23rd & Union-Jackson Residential Urban Village

DRAFT ZONING CHANGES to implement Mandatory Housing Affordability (MHA)

23RD & UNION-JACKSON URBAN VILLAGE NEIGHBORHOOD WORKSHOP

FEEDBACK ON PROPOSED URBAN VILLAGE ZONING CHANGES*

Zone Change Feedback

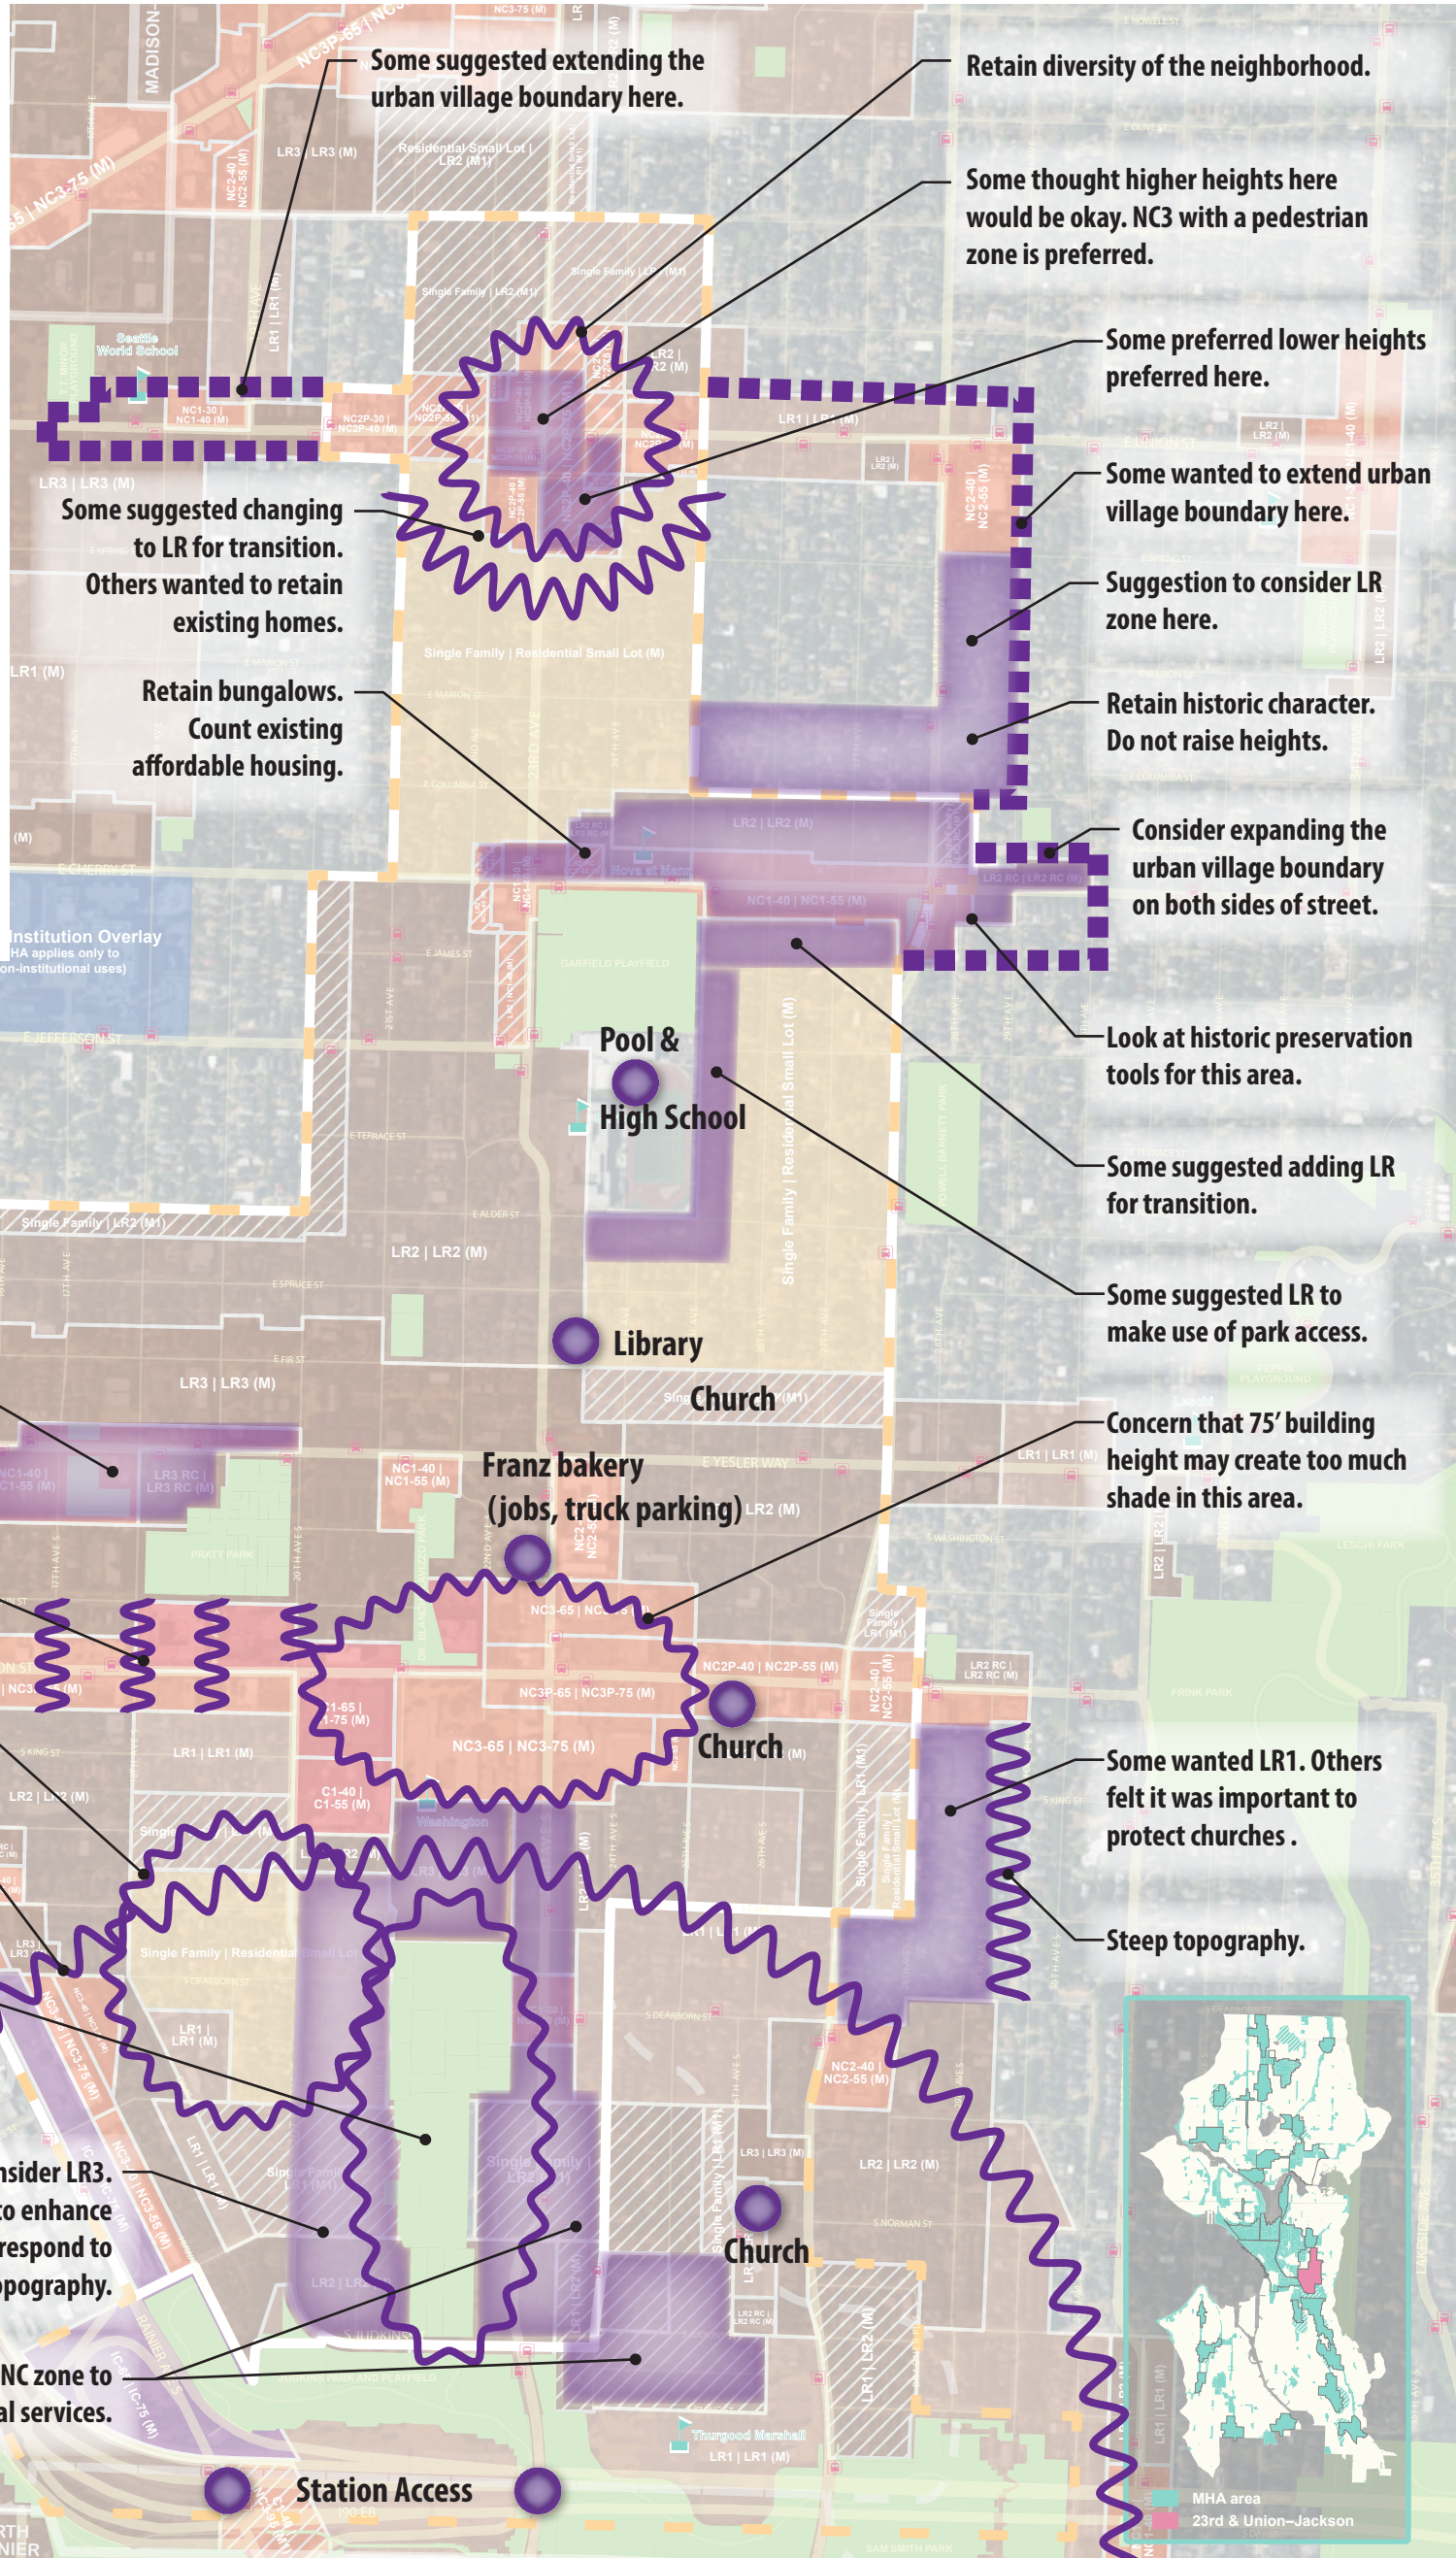
Some suggested extending the urban village boundary here.

Retain diversity of the neighborhood.

Some thought higher heights here would be okay. NC3 with a pedestrian zone is preferred.

Some preferred lower heights preferred here.

Some wanted to extend urban village boundary here.

Suggestion to consider LR zone here.

Retain historic character. Do not raise heights.

Consider expanding the urban village boundary on both sides of street.

Look at historic preservation tools for this area.

Some suggested adding LR for transition.

Some suggested LR to make use of park access.

Concern that 75' building height may create too much shade in this area.

Some wanted LR1. Others felt it was important to protect churches.

Steep topography.

Some suggested changing to LR for transition. Others wanted to retain existing homes.

Retain bungalows. Count existing affordable housing.

Suggestion to consider NC2 with provisions for affordable commercial space.

Side streets are important for business.

There are some good models for RSL in this area.

DISCUSSED AT MULTIPLE TABLES: Increase density around the light rail station but retain fine grain scale of neighborhood character.

Adjacent development could create a mini Central Park.

Consider LR3. Step height to enhance park and respond to topography.

Consider NC zone to provide local services.
